Permit #:	PW2312-015
Site Address:	2800 35th Ave Ne
Owner:	Aleksander Vasilyev
App. Date:	12/22/2023
Description:	Sitework For Outdoor Storage Parking Lot

City of Everett Permit Services
REVIEWED FOR CODE COMPLIANCE
 By Review Discipline: Public Works
 Reviewer: Therman
 Date: 05/30/2025
 Review Status: Approved for Permit

APPROVED AS NOTED

COVER SHEET
EVERETT PARKING LOT
ALEKSANDER VASILYEV
 19717 144TH AVE NE
 WOODINVILLE, WA 98072

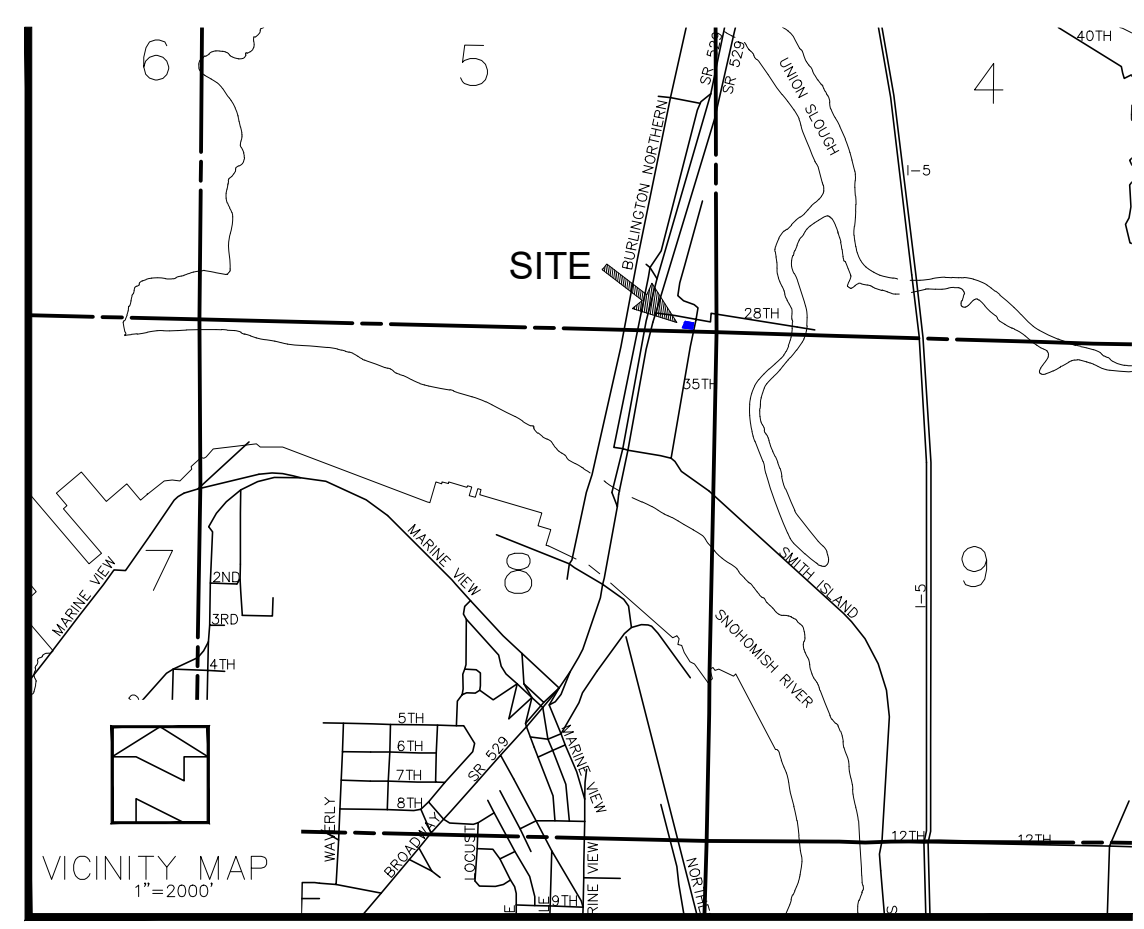
The crosswalk shown here must be installed prior to final inspection approval

Condition: The proposed carport are not approved under this permit. If the applicant wants to construct the carports a new shoreline permit is required. If a shoreline permit is obtained for the carports, the applicant will then need to obtain all applicable construction permits for the carports

SWPPP PLAN
EVERETT PARKING LOT
ALEKSANDER VASILYEV
1917 144TH AVE NE
WOODINVILLE, WA 98072

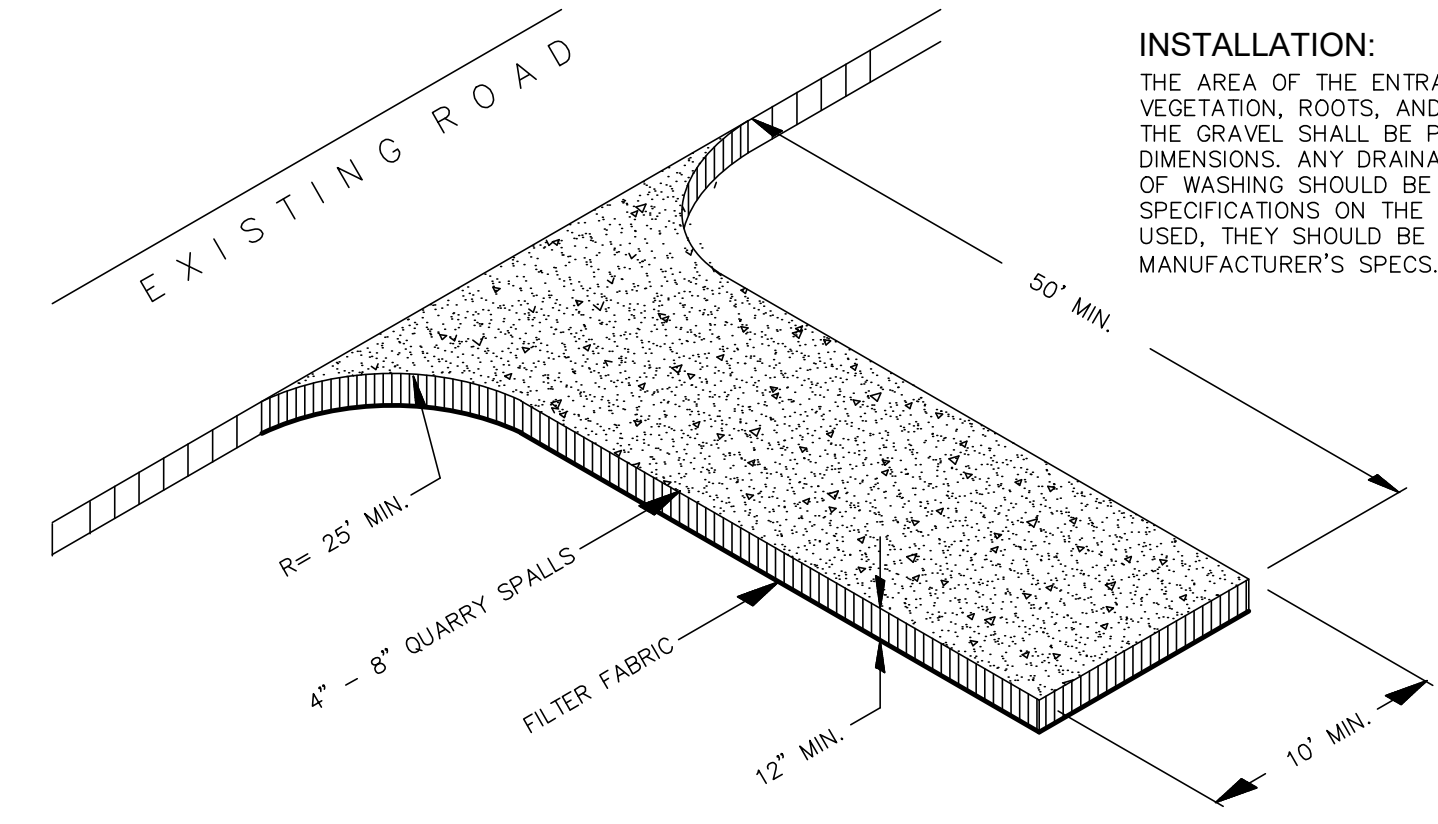
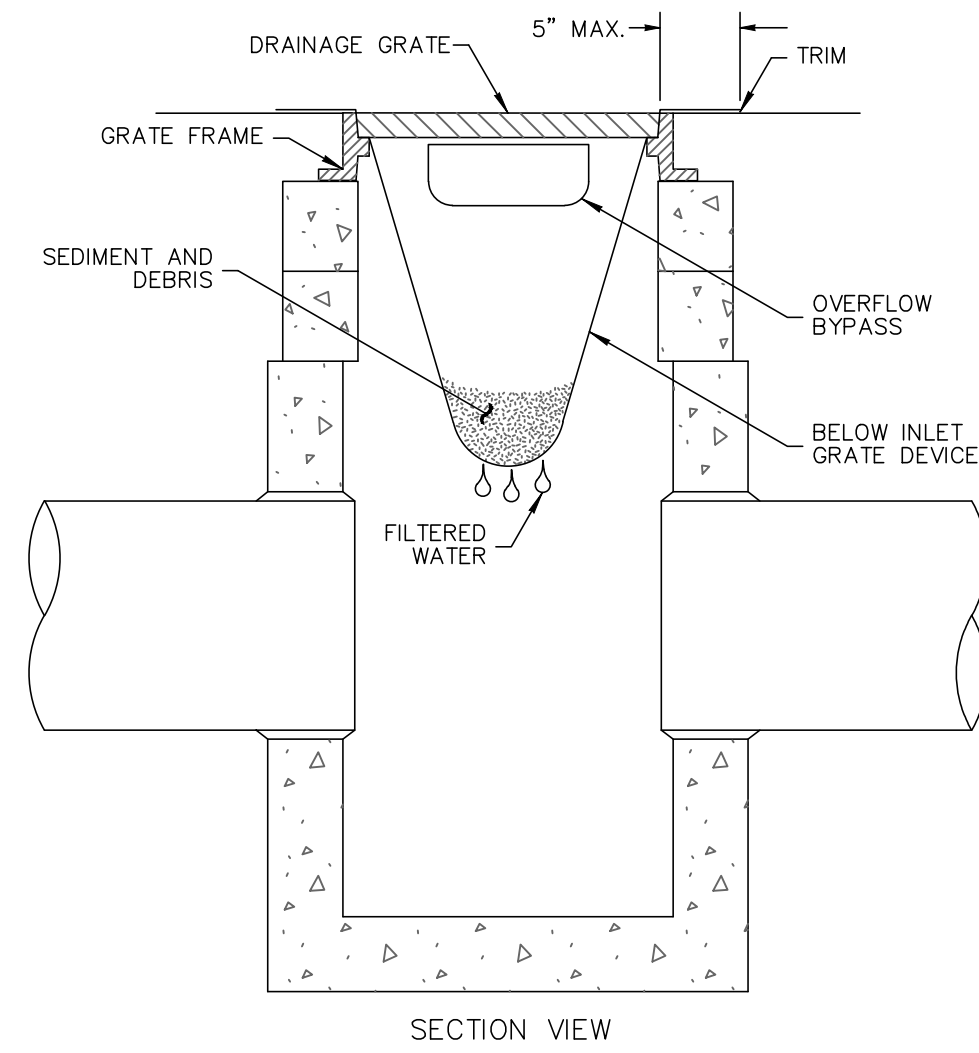
Bypass for existing ditch may be needed during culvert construction.
